PLANNING COMMISSION MEETING

LOCATION: TOWNSHIP ANNEX, 7527 HIGHLAND ROAD, WHITE LAKE, MICHIGAN, 48383
(FORMER WHITE LAKE LIBRARY)
THURSDAY, JANUARY 06, 2022 – 7:00 PM

RE: Taco Bell Preliminary Site Plan Review – 1st Review

Subject: Taco Bell
Preliminary Site Plan Review #2
Zoned: Planned Business (PB) District

A0.6

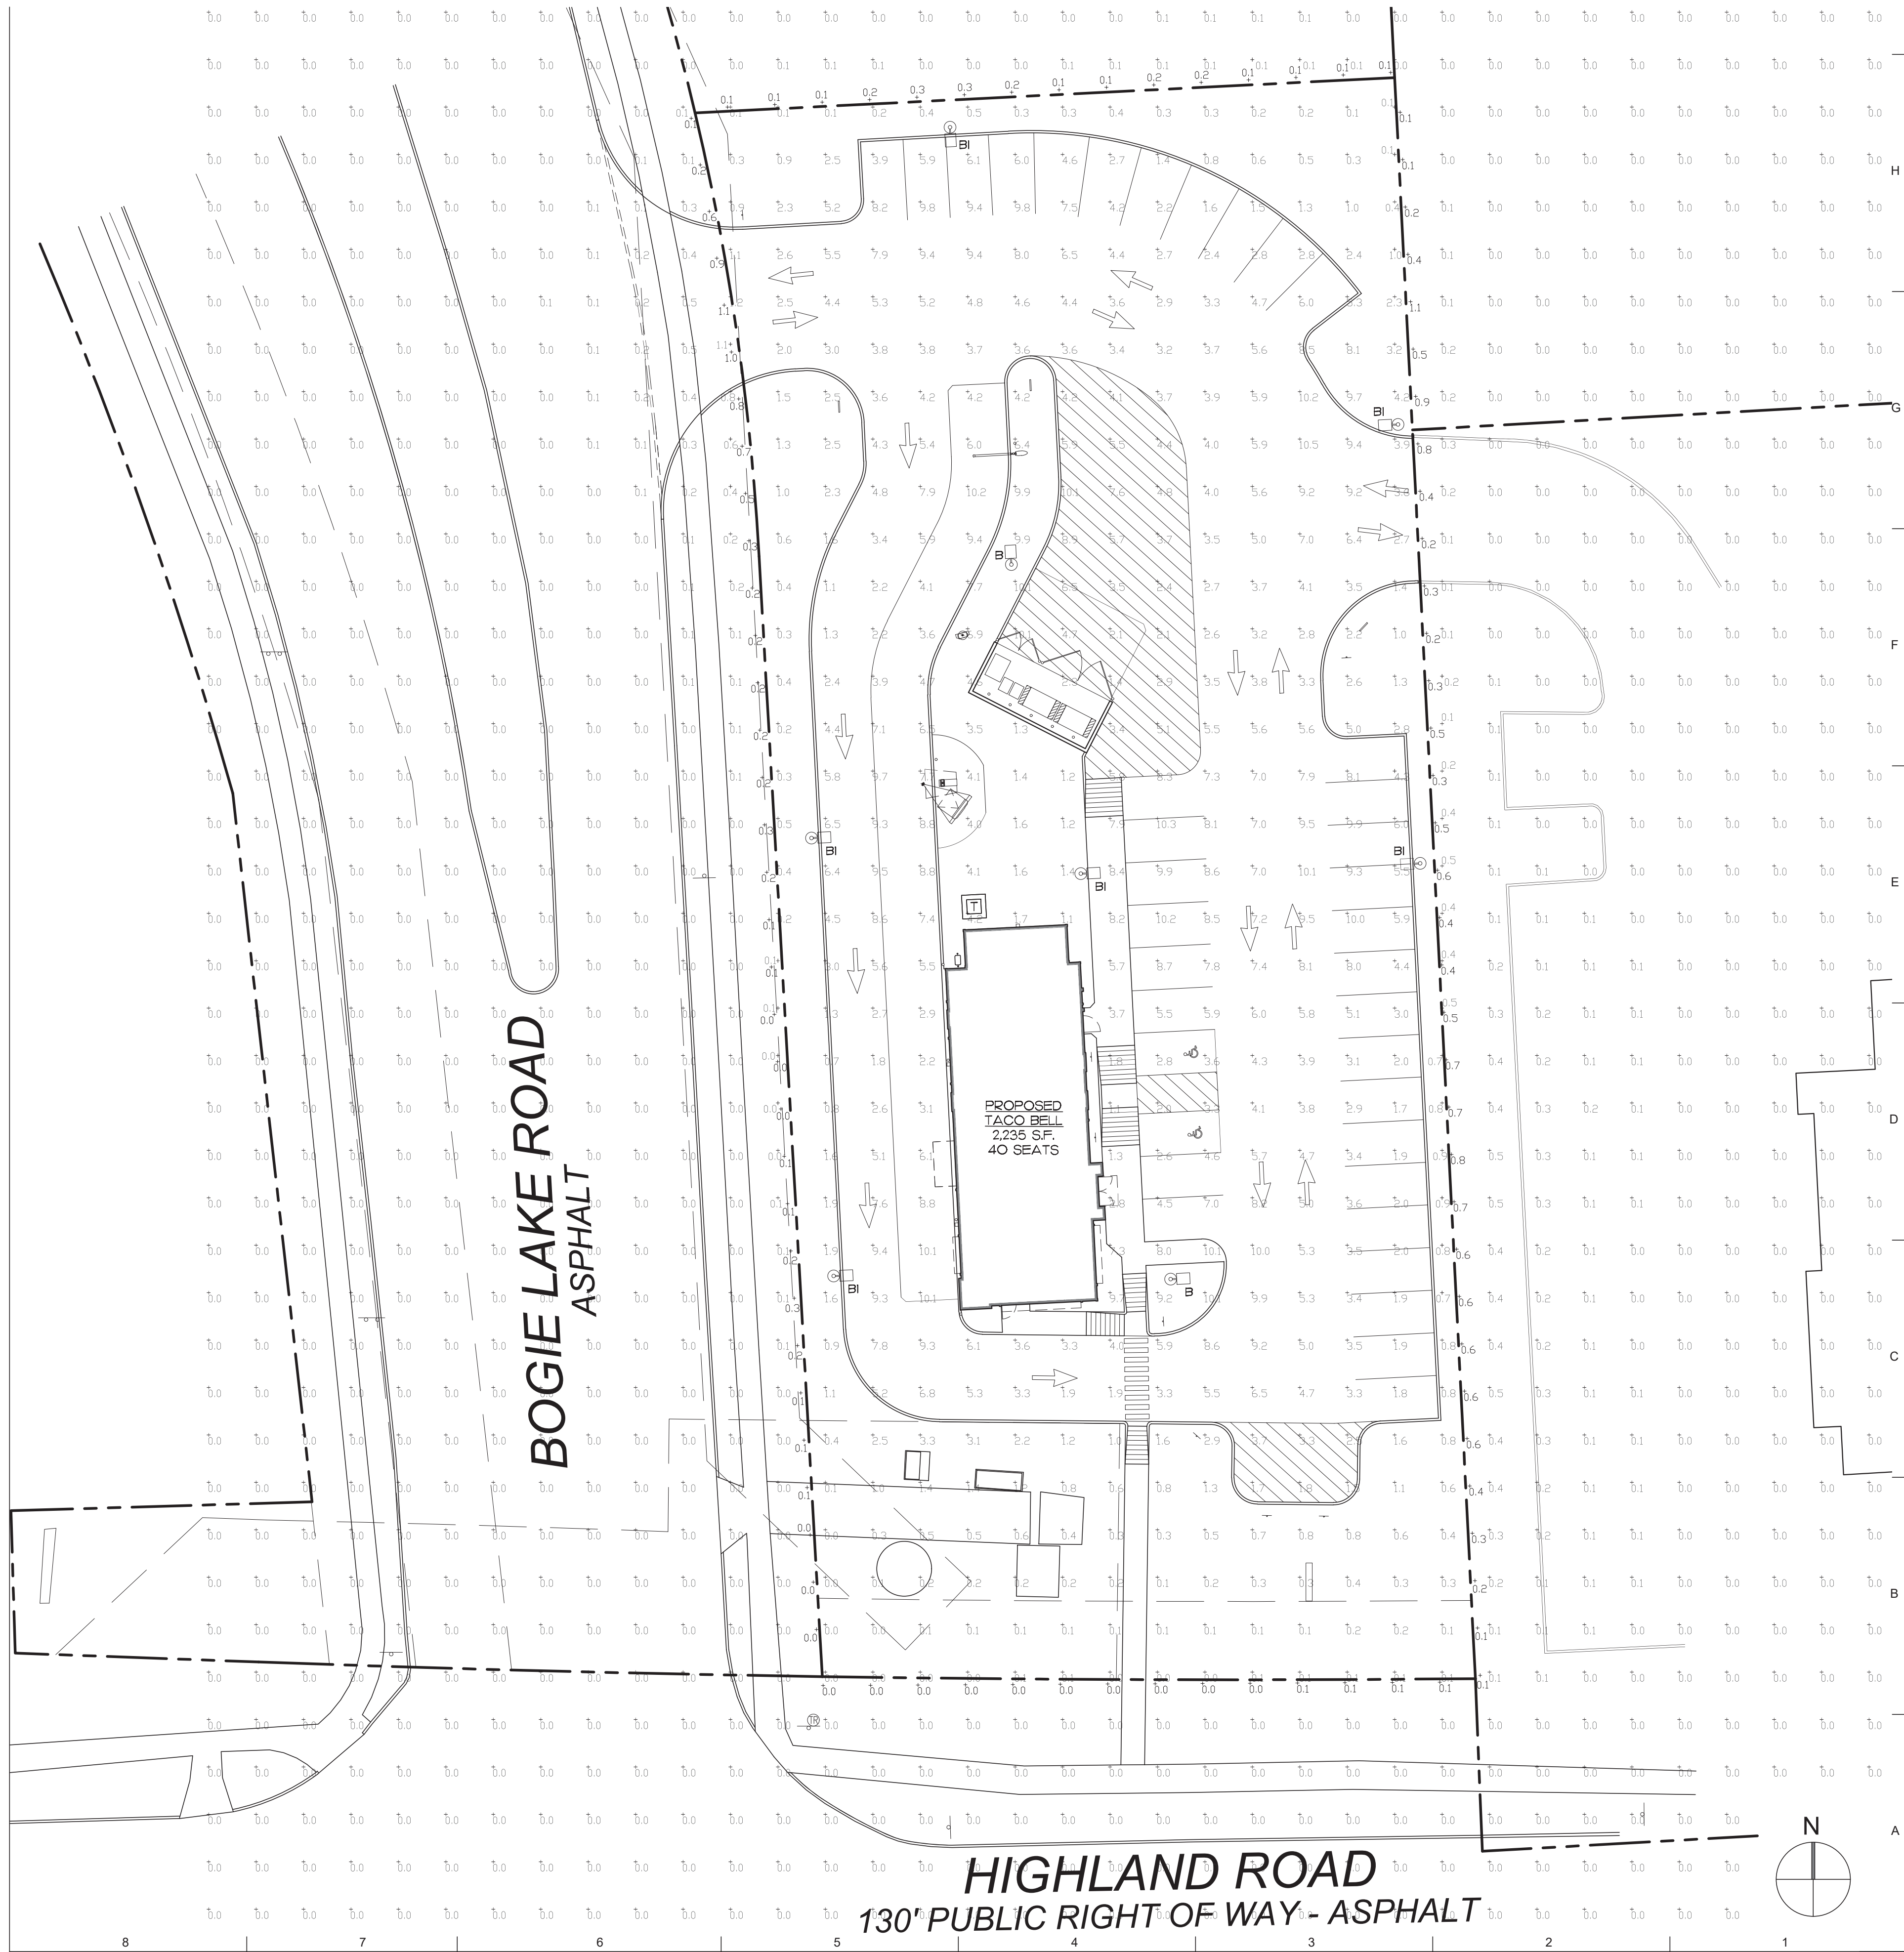
- 4. **Site Circulation and Parking.** The site does not have a curb cut on to Highland Road; rather it is accessed from a curb cut off of Bogie Lake Road and a proposed shared access easement with the McDonald's to the east. Because of the location of the drive thru lane in relation to the Bogie Lake Road entrance, there may be a traffic conflict. The petitioner should address this at final site plan review. There is a possibility of vehicles backing up onto Bogie Lake Road to enter the drive thru lane and blocking the fire lane. The alternative (with

Fast food restaurant uses are required to have one parking space for every 75 square feet of gross floor area. A total of 30 spaces are required. The site plan proposes 37 spaces on site, including two barrier free spaces on the east side of the site, closest to the building in compliance with the Zoning Ordinance.

Additionally, restaurants operating drive-thru windows with indoor seating are required to provide eight (8) stacking spaces. The applicant has provided 9 stacking spaces, which satisfies this requirement.

A0.7

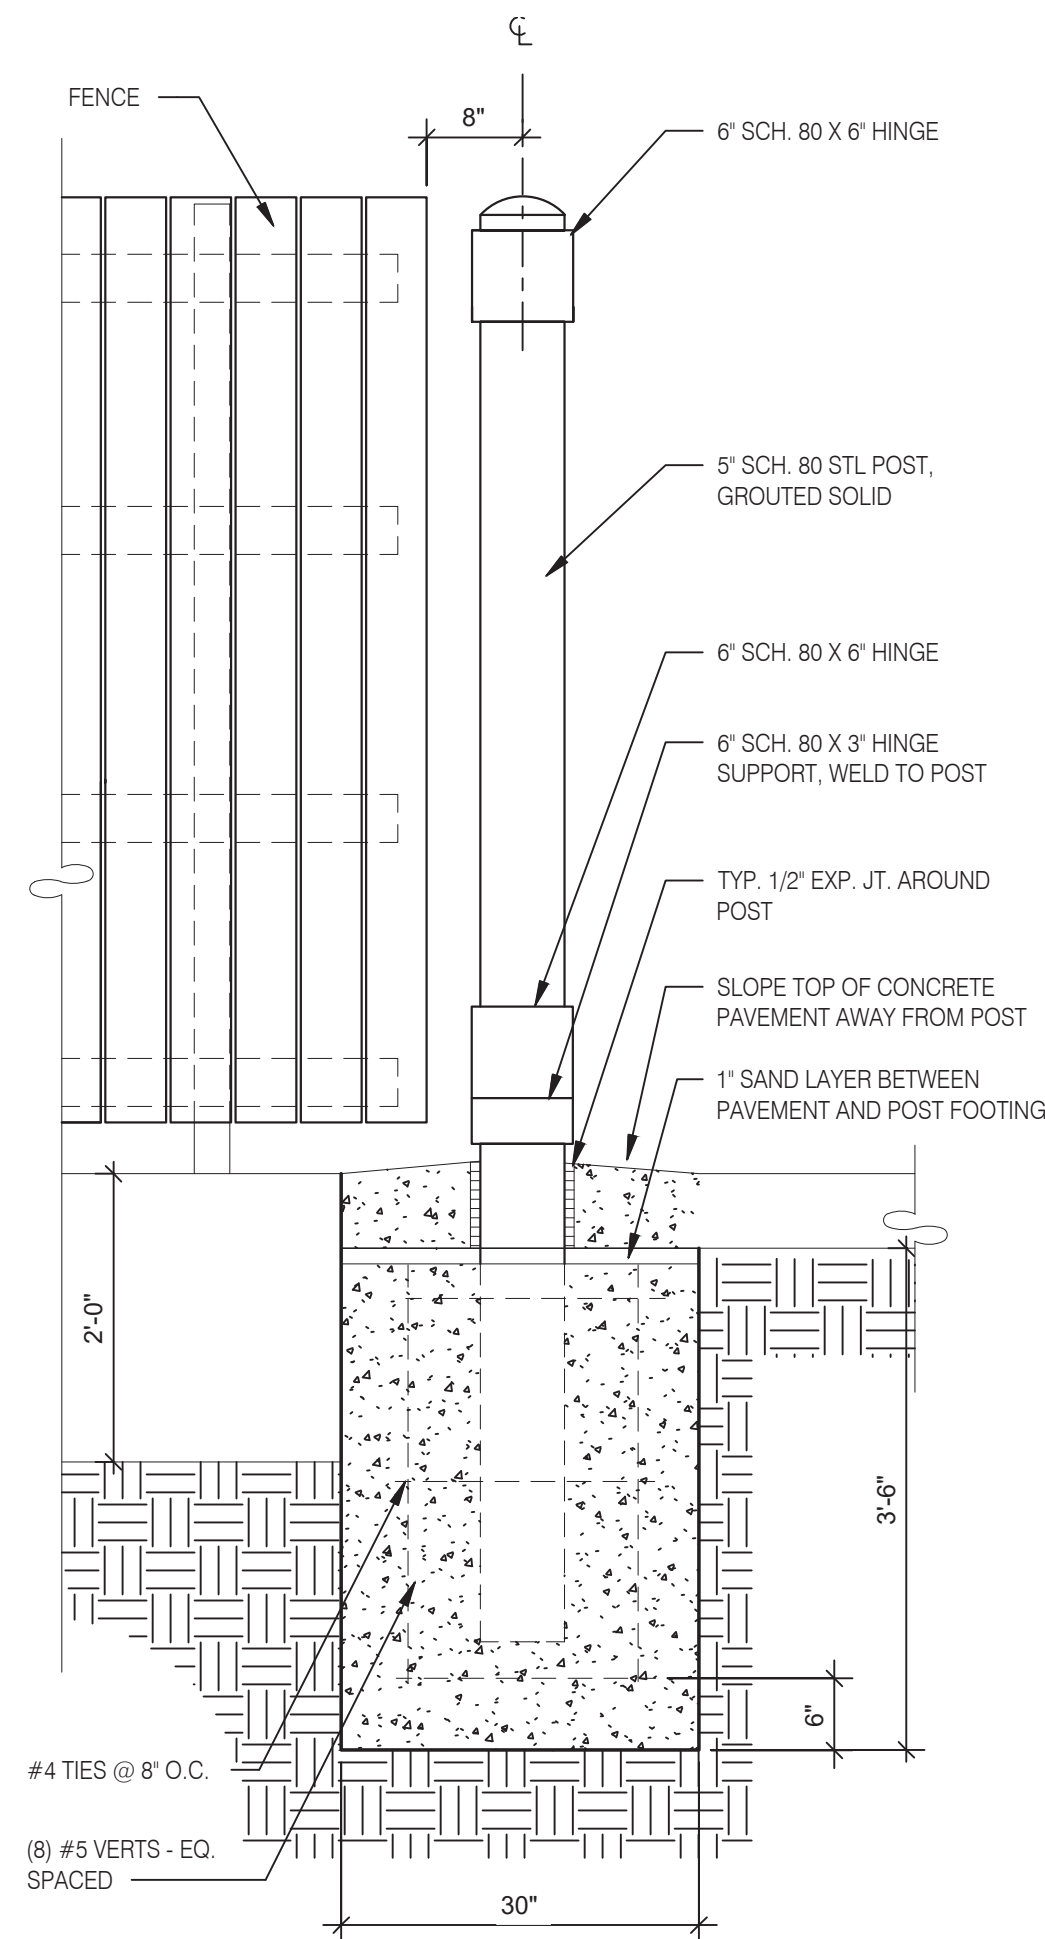
- 7. **Lighting.** Section 5.18(G) of the Zoning Ordinance includes the standards for outdoor lighting. A photometric plan was submitted, although no details were provided for lighting mounted on the building. The Zoning Ordinance does not require a review of the lighting plan until final site plan review. As proposed, the pole lights appear to meet the Zoning Ordinance requirements with the exception of a 1.1 foot-candle at the Bogie Lake curb cut and a 1.1 foot-candle on the northeast property line. Additionally, the photometric site plan indicates that the average foot-candle level in the parking and drive areas is 5.28. **The Zoning Ordinance allows a maximum foot candle average of 2.0.** A thorough review, including building mounted fixtures, will have to be conducted at final site plan review. Details were not supplied as to the outdoor light fixtures that are mounted on the building. Additionally, the petitioner is proposing a "purple light wall washer" on the Highland Road, Bogie Lake Road and east elevations. The Planning Commission should determine whether or not this type of lighting is appropriate.

- c. **An outdoor lighting plan shall specify the type of fixtures to be used, light intensity, and method of shielding the fixtures so that light does not project onto adjoining properties or on any public or private street or right-of-way. Dropped fixtures shall not be allowed.** See notations above regarding lighting.

- g. **Lighting shall be shielded from adjacent property and designed to reflect continuity with the pedestrian orientation of the area. Floodlights, wall pack units, and other types of unshielded lights, and lights where the lens or bulb is visible outside of the light fixture are not permitted except in service areas where the lights will not generally be visible by the public or adjacent residential properties. Lights underneath canopies must be fully recessed into the canopy to minimize glare from the light source.** A detailed lighting plan with specifications on all light fixtures must be submitted at final site plan review.

G2.0

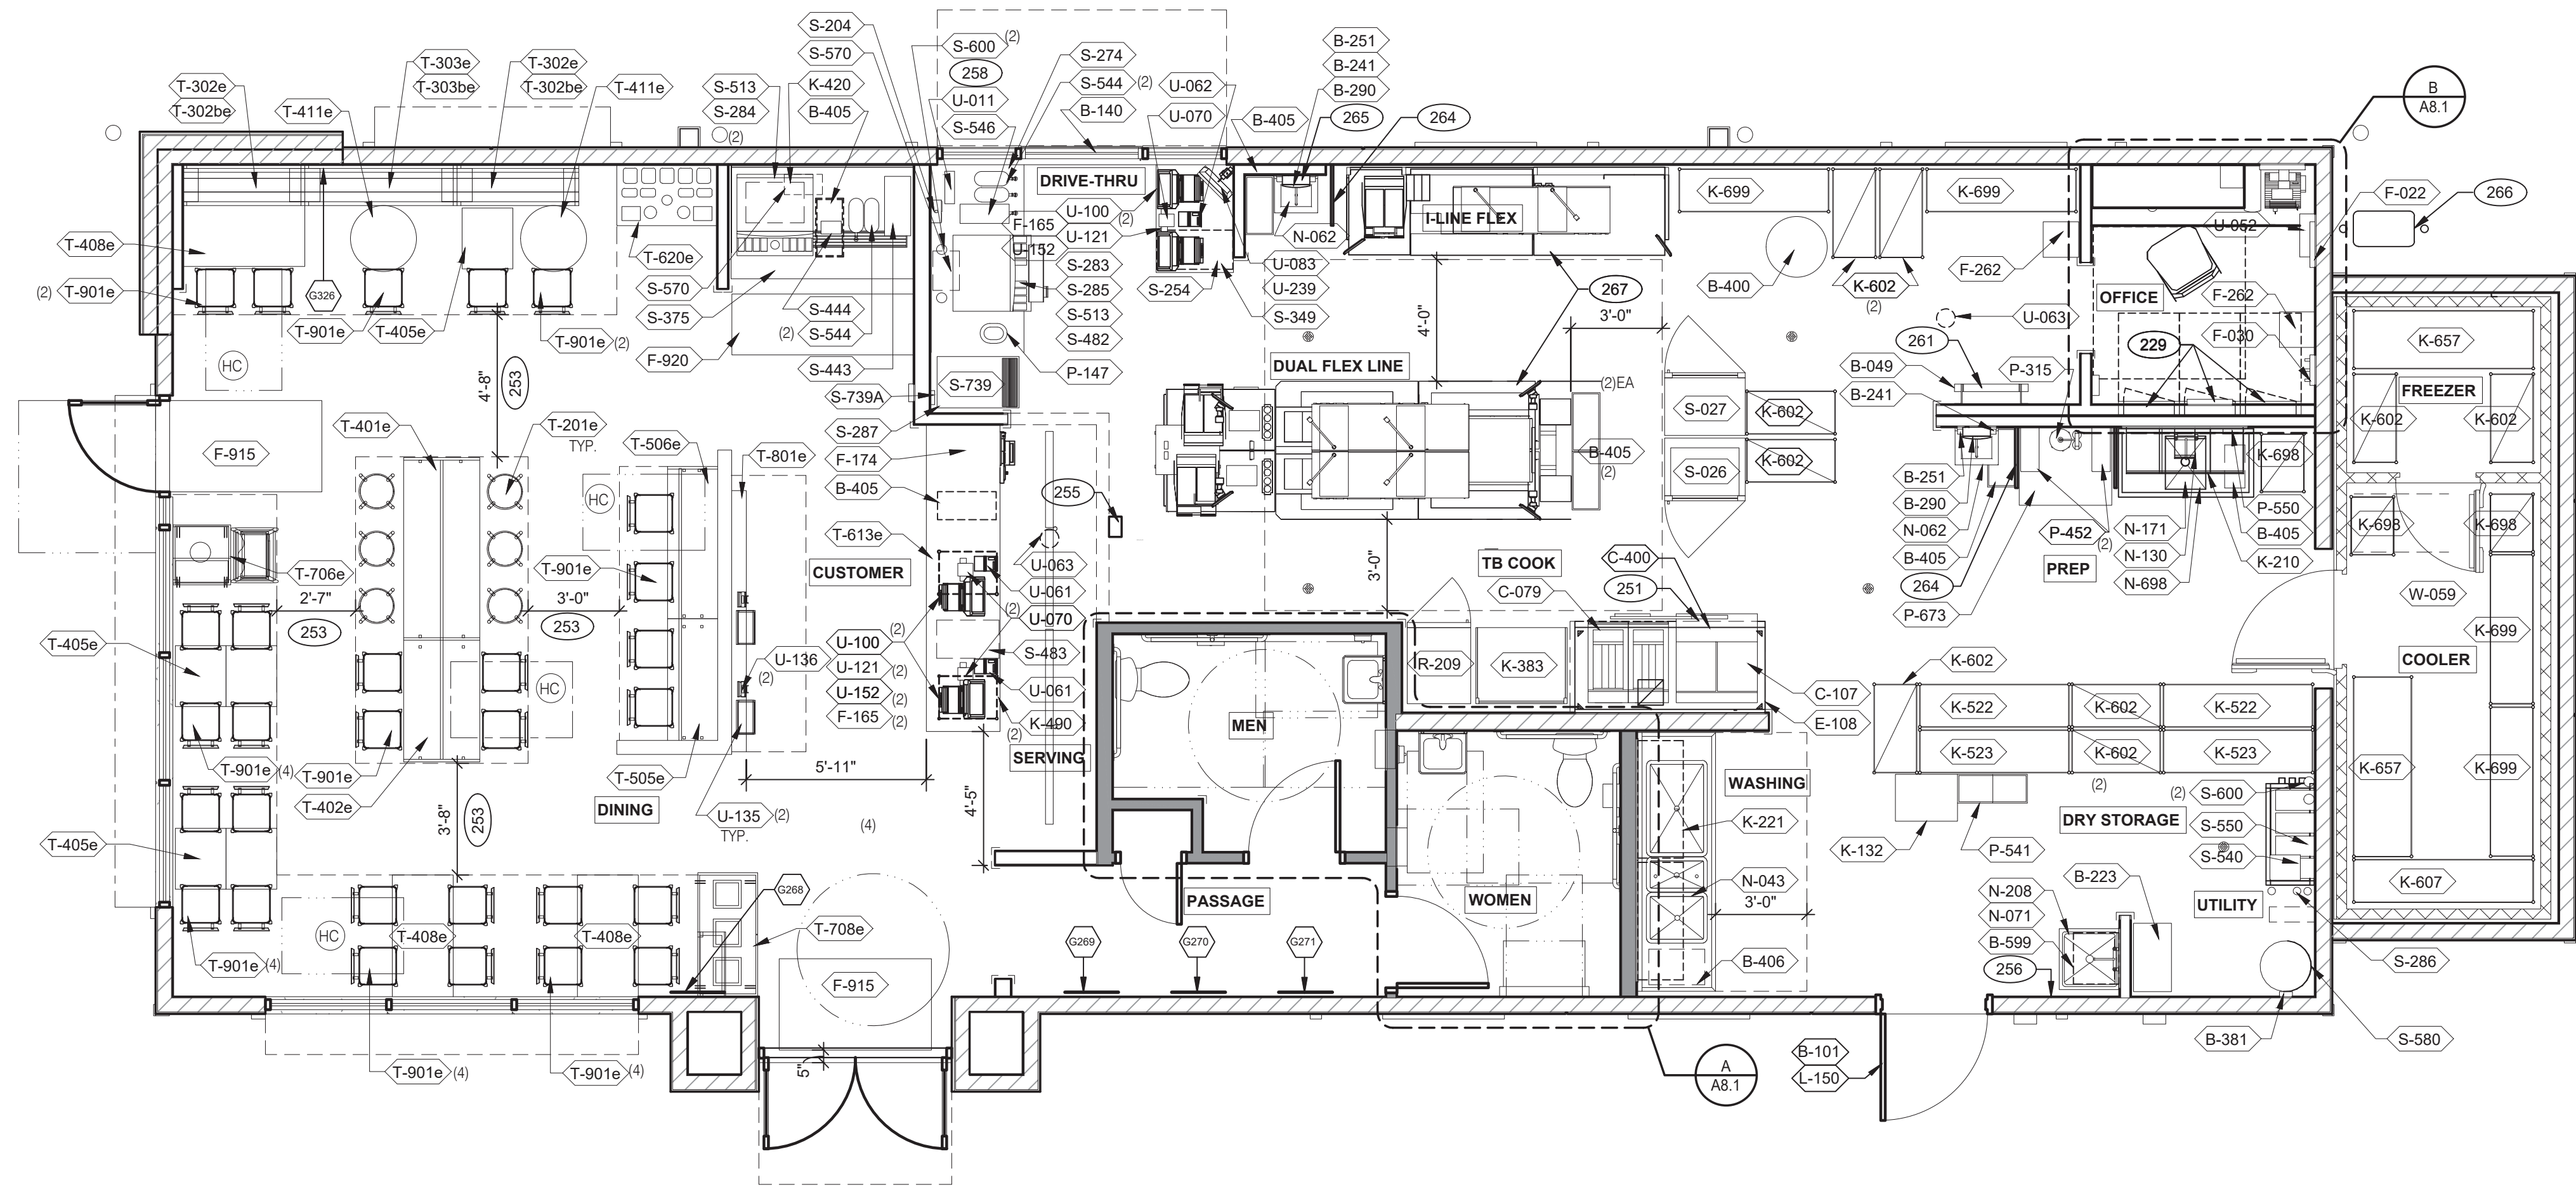
9. **Trash Disposal.** The site plan indicates a trash enclosure will be located to the rear of the building, adjacent to the loading and unloading area. The enclosure is 9'-5" x 26' and is located on a 7" thick concrete pad. The proposed enclosure consists of plastic lumber pickets and is 5'-9" in height. **The Zoning Ordinance requires enclosures to be between 6' and 8' in height.** The gate consists of the same plastic lumber pickets. The Zoning Ordinance requires trash storage enclosures to be constructed of the same decorative masonry materials as the building which they are accessory to. The petitioner needs to revise the material and the height of the enclosure and fence to meet the Zoning Ordinance requirements as noted in section 5.19(N)(i).
